Drawings

The drawings were objected to. The Examiner stated:

Fig. ~~fig.~~ 4B

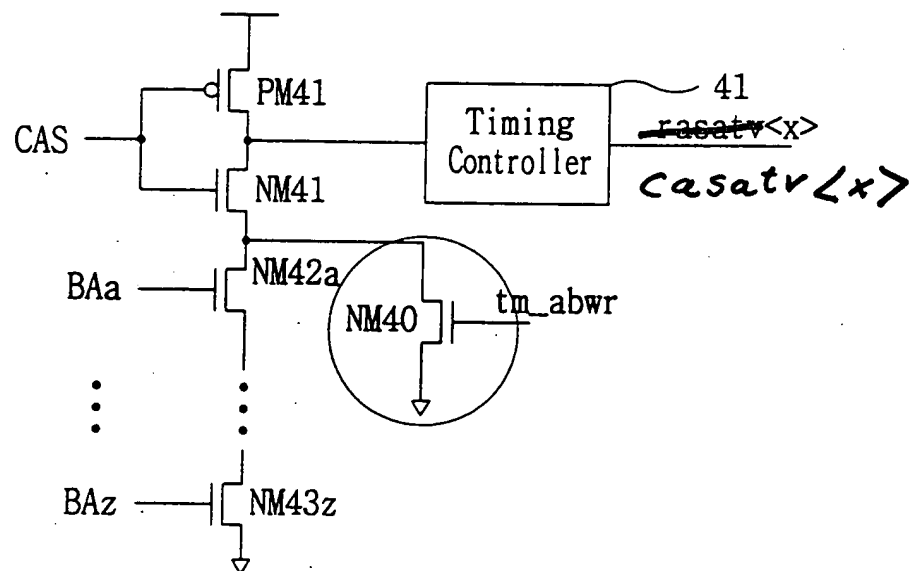
The drawings are objected to because in figure 4B, the signal "rasatv<x>" should read --casatv<x>-- and in figure 5, the reference "60" as described in the specification is missing.

The proposed correction to the drawing of Fig. 4B corrects "rasatv<x>" to --casatv<x>-- to obviate the Examiner's objection. Support for the proposed correction is found at page 7, line 18, of the specification.

Fig. 6

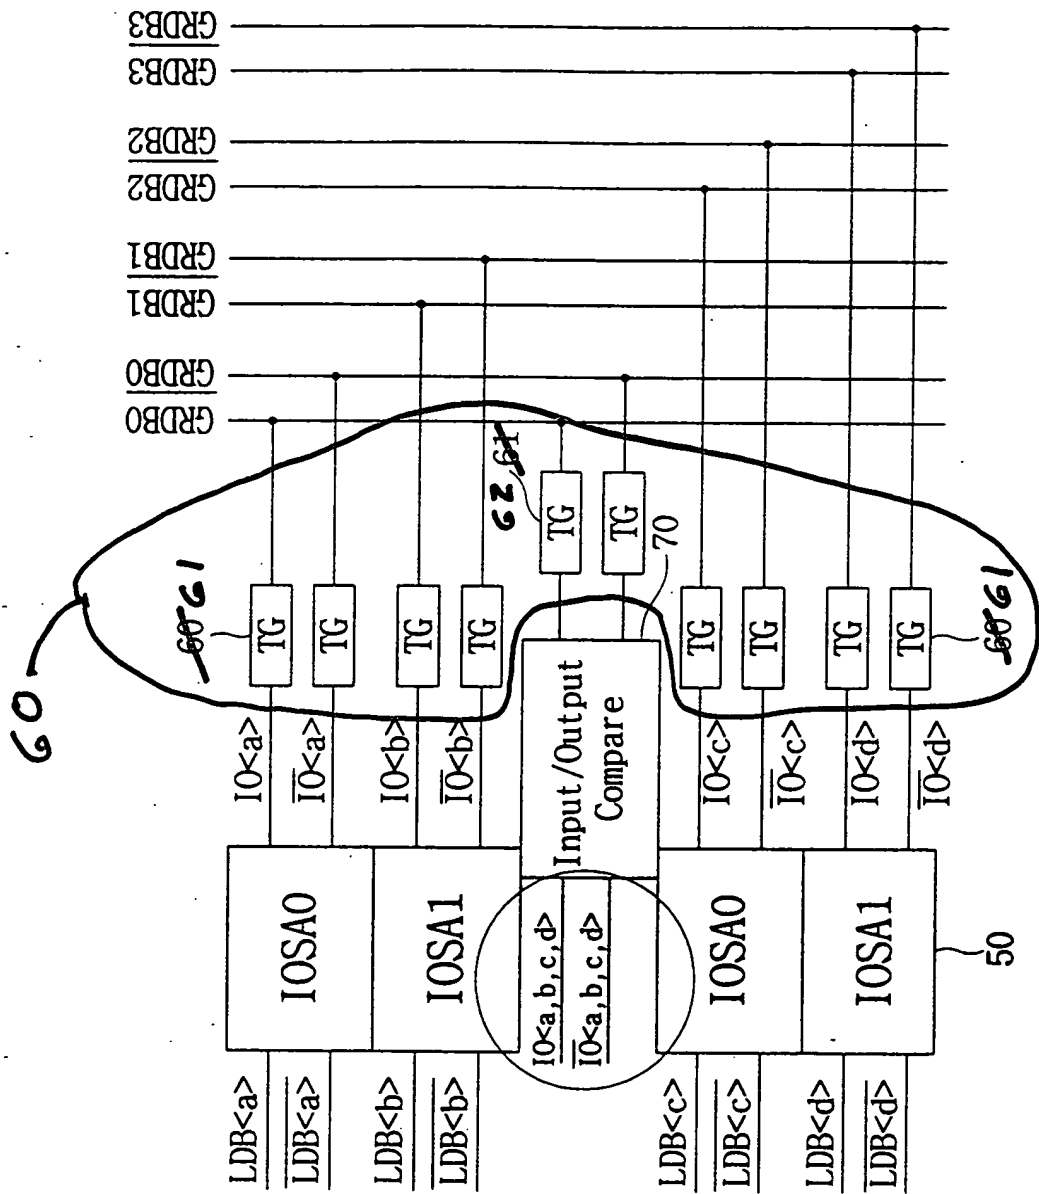
The proposed corrections to the drawing of Fig. 6 are to correct typographical errors relating to the first and second transmission gates and to identify those aspects of Fig. 6 which

comprise element 60. Support for adding reference numeral --60-- is found at page 7, lines 29-31, of the specification. Support for changing existing reference numeral "60" to --61-- is found at page 7, line 31, through page 8, line 1, of the specification. Support for changing existing reference numeral "61" to --62-- is found at page 8, lines 6-8, of the specification.
